MODIFICATION TO MAJOR PROJECT M09_0183

**Telopea Urban Renewal Project - Stage 1:
Shortland and Part Moffatts Precinct
Redevelopment**

**LOT 101 DP 1169945 (*PREVIOUSLY KNOWN
AS LOTS 219A, 219B & J DP 36743
SHORTLAND PRECINCT*)
AND LOT 1724 DP 216673**

October 2014

CONDITION B

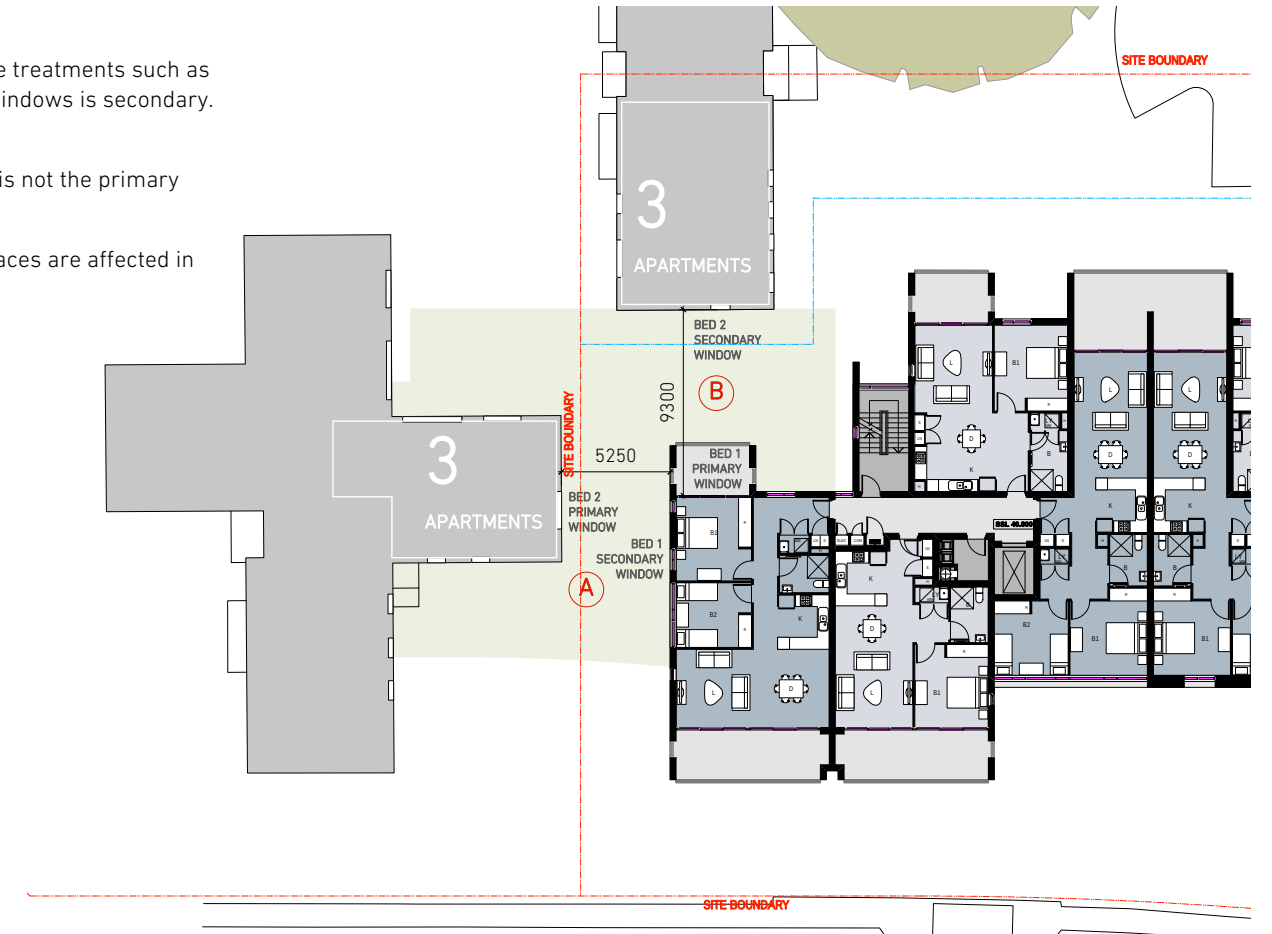
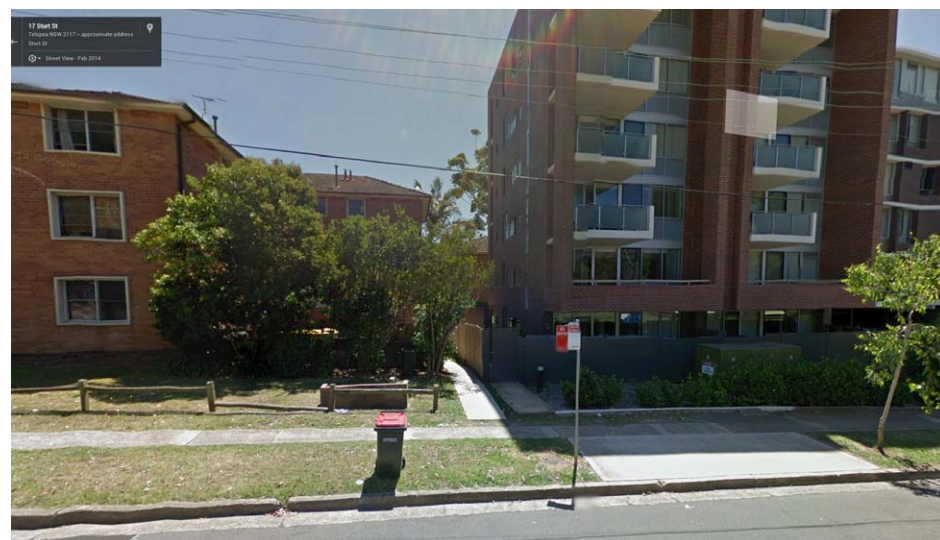
The apartment in Moffatts includes bedroom 1 of a 2-bed apartment. On this face of the building there is the primary glazing with a small balcony.

Opposite this is bedroom 2 of the apartment in Block 6 that has its secondary window facing towards Moffatts.

The distance between the buildings' glazing is approximately 9.3m.

Neither of the rooms in question is a living room, so the occupancy of the rooms is likely to be intermittent, and windows are likely to include treatments such as curtains or blinds. Therefore from a visual amenity viewpoint the disturbance between the two apartments is low, especially as one of the windows is secondary. The inclusion of a balcony also acts as a further layering between the neighbouring building and the glazing in Moffatts.

From an acoustic privacy point of view, the effects of noise transmission is likely to be relatively low as the balcony to Moffatts is small and is not the primary balcony for the apartment.

CONDITION C

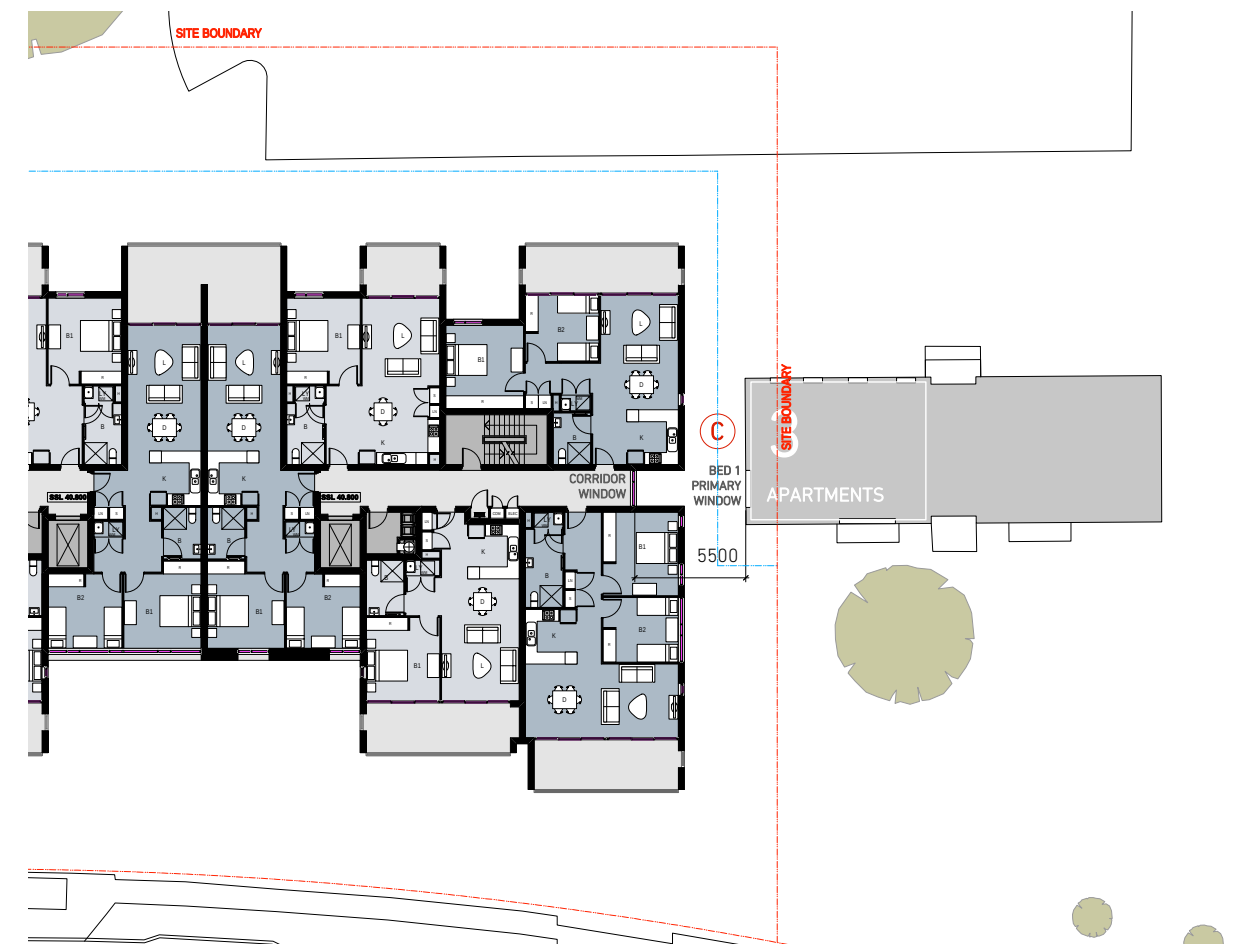
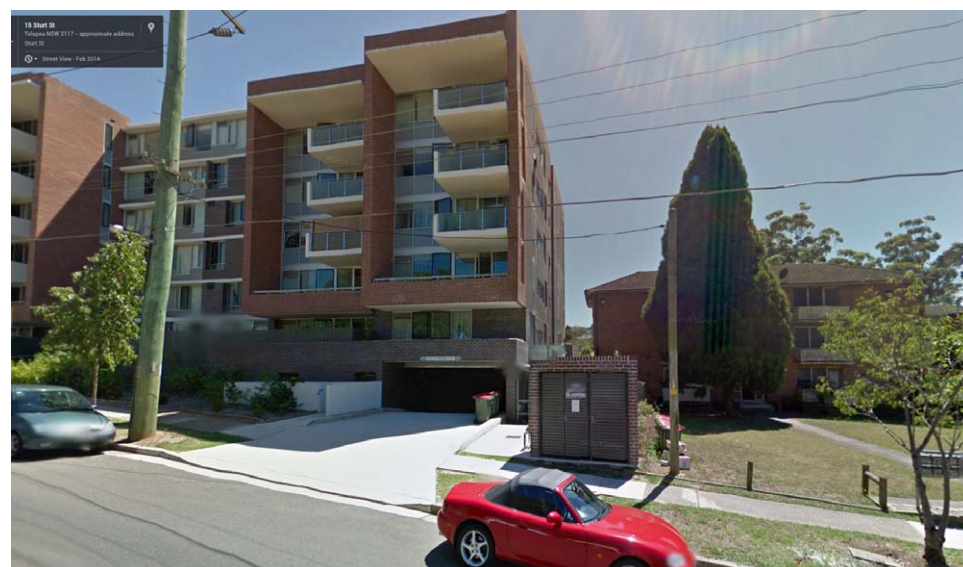
The window in Moffatts is to the end of the lift lobby corridor. Opposite this is a bedroom 1 of the apartment in Block 12 that has its primary window facing towards Moffatts.

The distance between the buildings' glazing is approximately 5.5m.

Neither of the spaces in question is a living room, so the occupancy of the rooms is likely to be intermittent, and the window to Block 12 is likely to include treatments such as curtains or blinds. Therefore from a visual amenity viewpoint the disturbance between the two spaces is low, especially as one of the windows is not to an apartment.

From an acoustic privacy point of view, as neither space includes a balcony, the effects of noise transmission is likely to be relatively low.

The residents of Block 12 in the three affected apartments might be contacted to ascertain whether they have felt their privacy affected by the proximity of the corridor window, and if this is the case, a translucent film could be fixed to the surface of the corridor windows to mitigate this situation.

Figure 3 Openings requiring protection on 17 Sturt Street

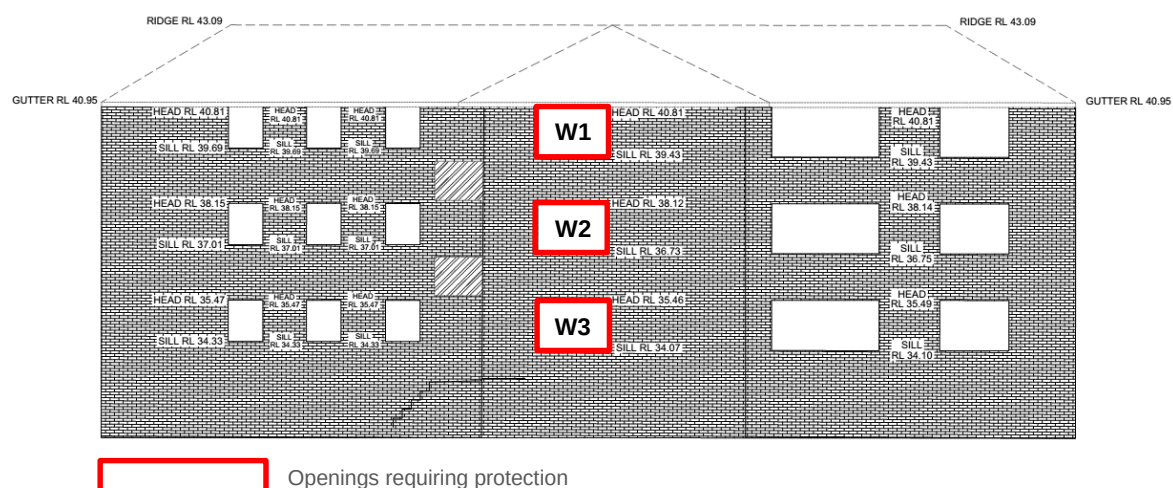
3. The openings described in Table 8 and shown in Figure 3 to Figure 6 must be protected in accordance with clause C3.4 of the BCA or with Crimsafe/Centra radiant heat attenuation screens – or equivalent – with the following characteristics:
- Material – 304 stainless steel.
 - Wire diameter – 0.9mm.
 - Weave characteristics – 10x10 weave, 10 strands per inch (394 wires per metre).
 - Opening ratio – 42%.
 - Finish – black polyester powder coating.
 - The screens must be mechanically fastened directly into the fire rated wall – or to 40mm x 40mm x 3mm thick steel angles which in turn are secured to the fire rated external wall – by steel screws. The steel fixing screws on every screen must go through the frame, the stainless steel mesh, the screw clamp and then into steel angle / wall. Other fixing methods must be reviewed and approved by Defire prior installation.

Figure 6 Openings on east elevation of 15 Sturt Street within 3m of subdivision boundary

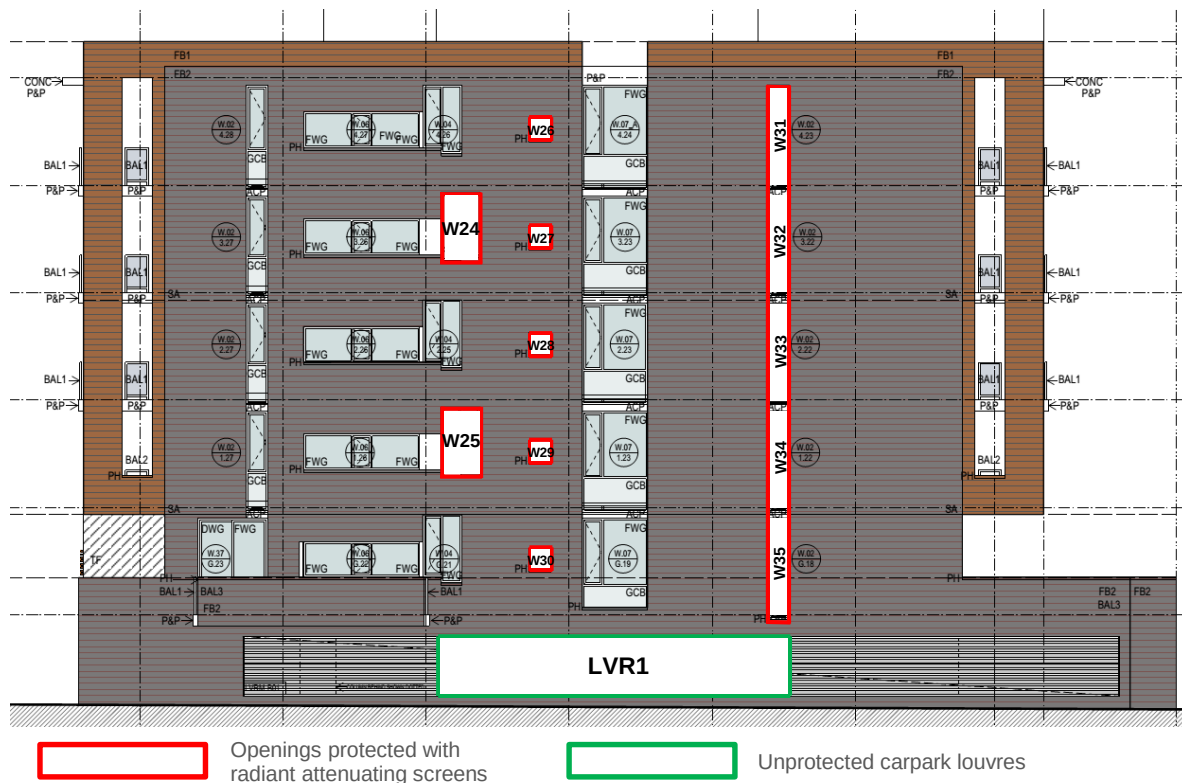
6. The carpark louvre opening LVR1 as shown in Figure 6 that is within 3m of the proposed subdivision boundary is not required to be protected in accordance with clause C3.4 of the BCA.

Figure 7 Unprotected openings on northern elevation of 13 Sturt Street

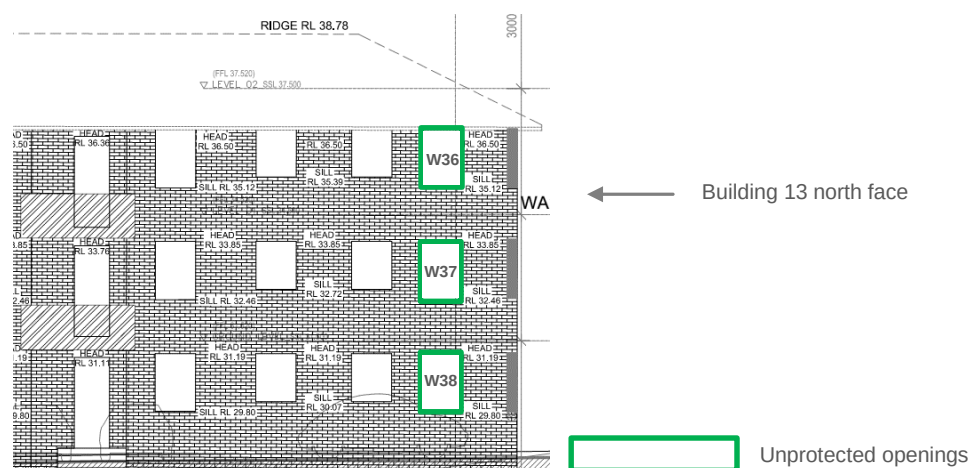
External openings W36, W37 and W38 on the northern elevation of 13 Sturt Street that are located at least 2.6m away from the eastern subdivision boundary – measured perpendicular – as shown in Figure 7 are not required to be protected.

Figure 8 Carpark floor plan of 15 Sturt Street

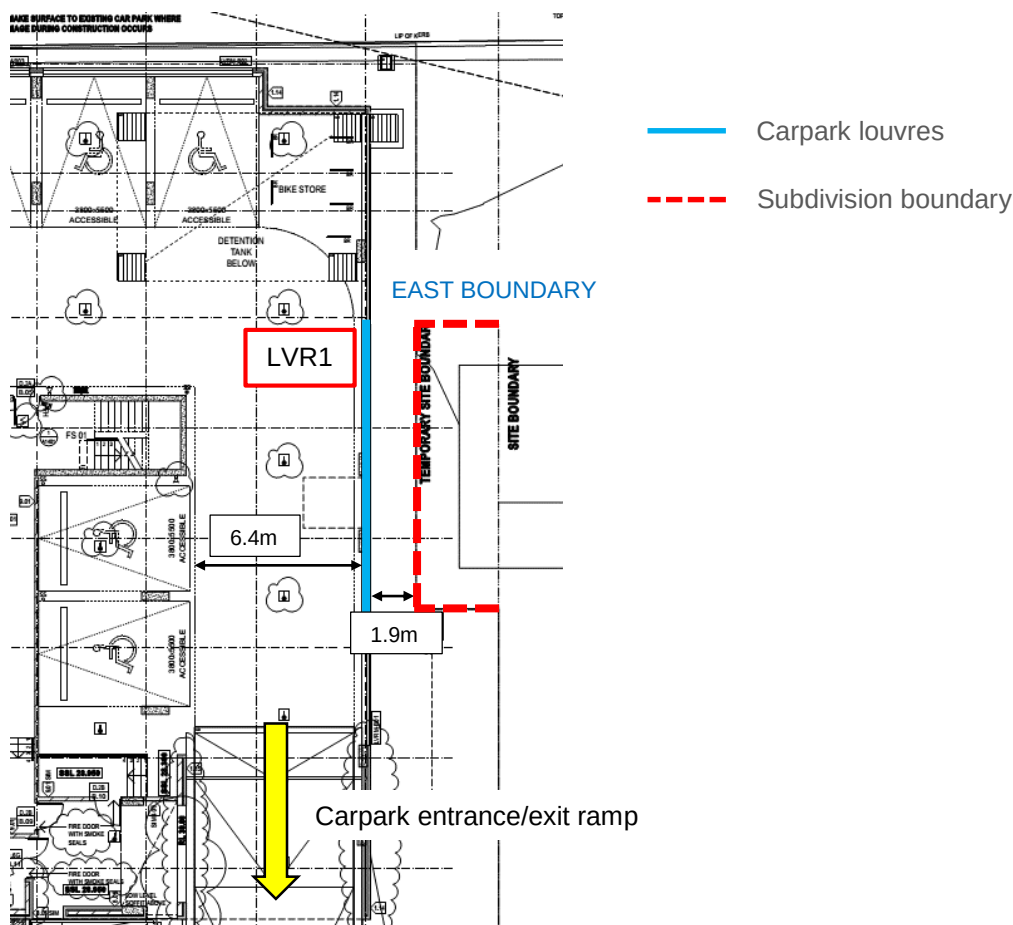
The carpark louvre opening on the eastern elevation of 15 Sturt Street is located approximately 1.9m from the proposed subdivision boundary and is not proposed to be protected. The location of the carpark louvre is illustrated in Figure 8.
